THE SUNRISE CITY
FORT PIERCE
PLANNING DEPARTMENT Florida

# DEVELOPMENT REVIEW

Property address or Location 4101 Oleander Avenue

Project description This project proposes a 32 unit apartment complex on Oleander Avenue with required parking, a garbage enclosure, public utilities and stormwater facilities to attenuate and treat stormwater.

SHEET
C3

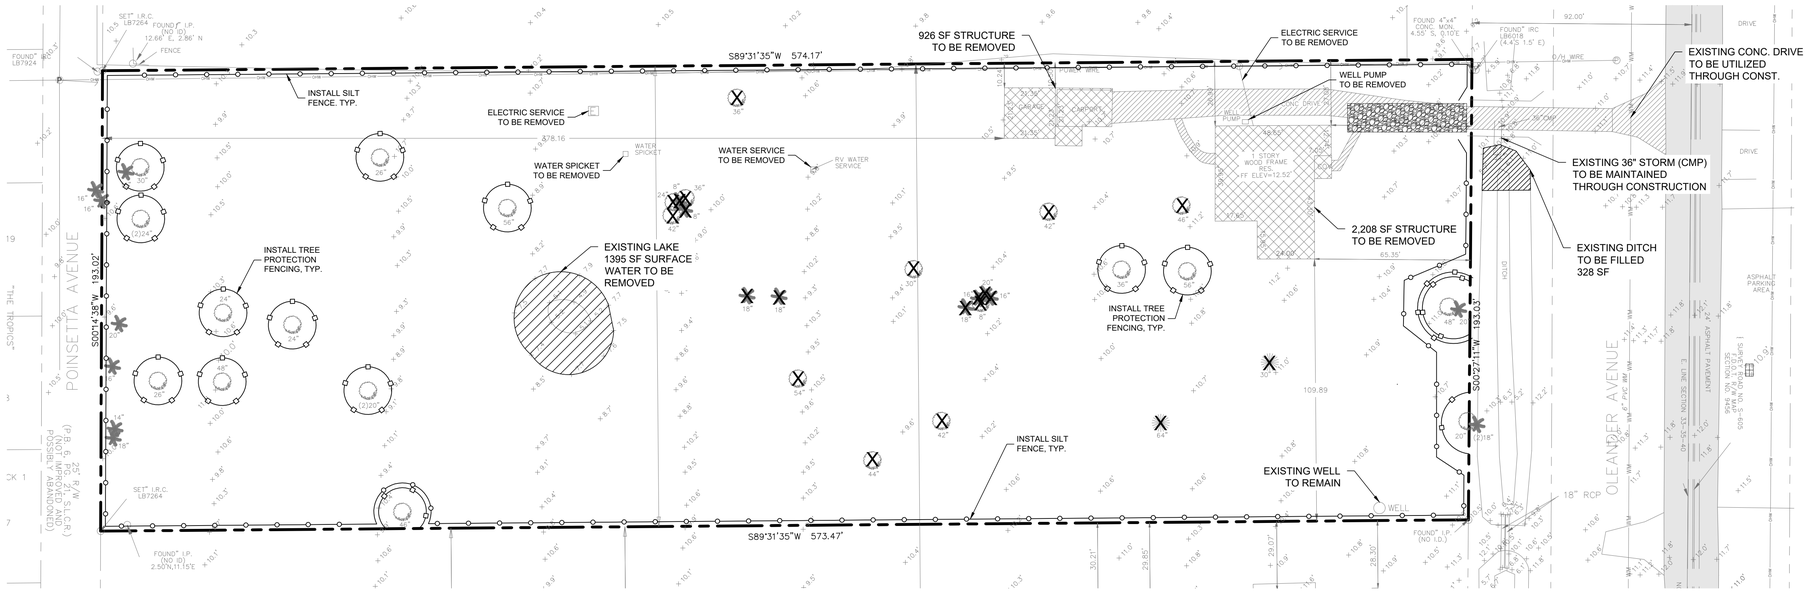
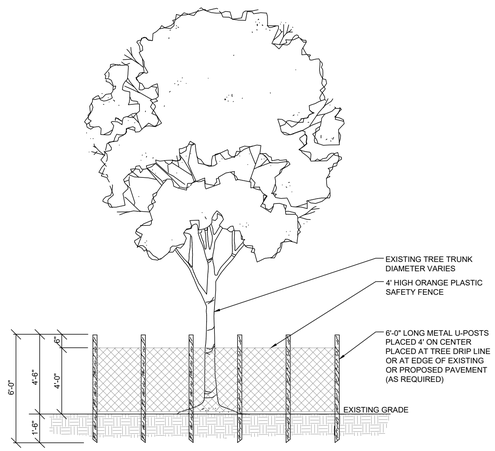
- Delineate the wetland on the site plan and acknowledge that it meets State mitigation on wetland. **The small 1,395 SF wetland/surface water is shown on the Existing Conditions Plan, Sheet C3.**

# SITE AND UTILITY PLAN

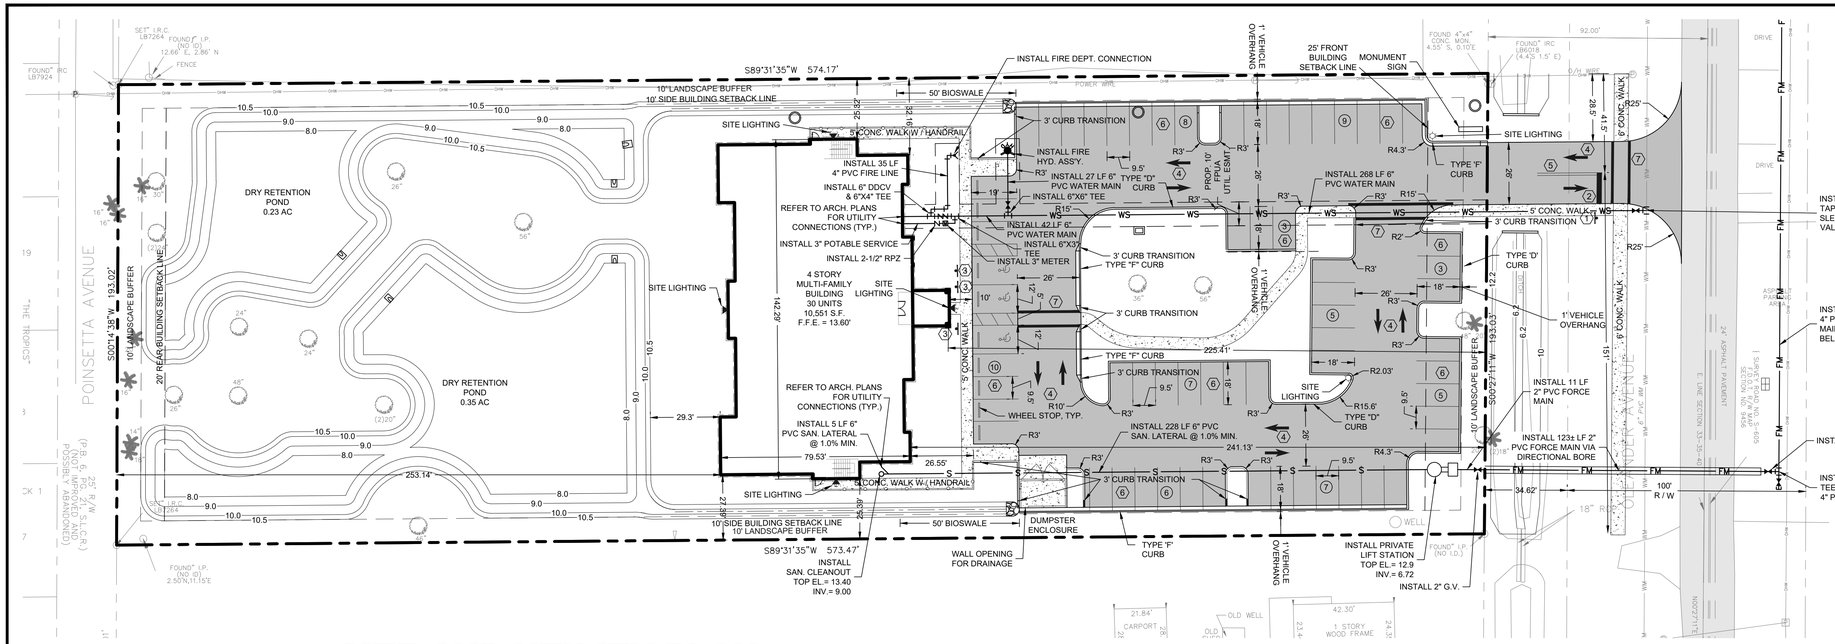
3. The Site Plan shall be revised to include the note that "All construction shall be in compliance with City of Fort Pierce Code of Ordinance Sections 119 and 125". **This note has been added to Sheet C4.**

## Existing Tree Inventory List

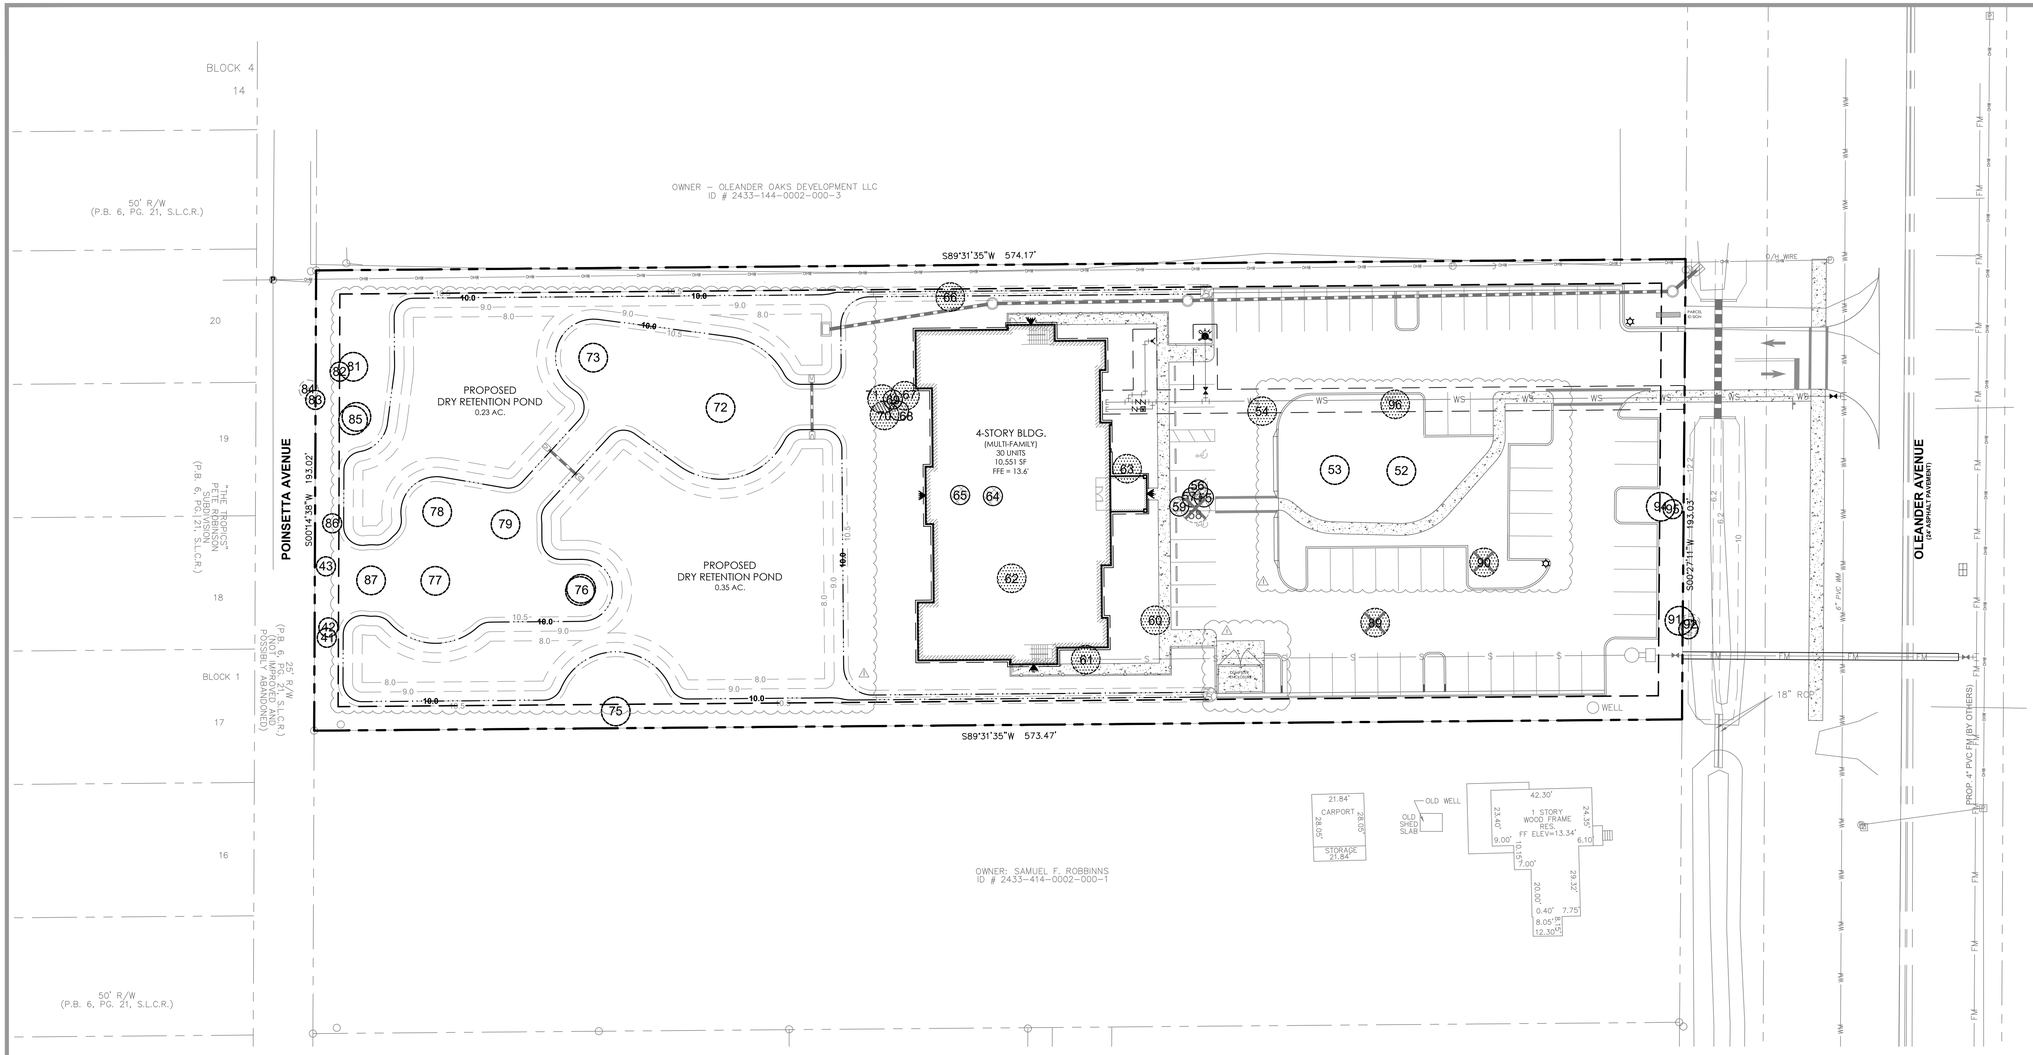
5. The landscape plans label existing trees as 1-47. However, the provided tree survey provides a numbering system of 41-96 for the existing trees. Please update the landscape plans so the tree identification matches what is provided on the survey. **Acknowledged. The Tree Inventory Plan has been revised to mirror the numbering system found on the existing tree survey as requested. (See Sheet L-2)**
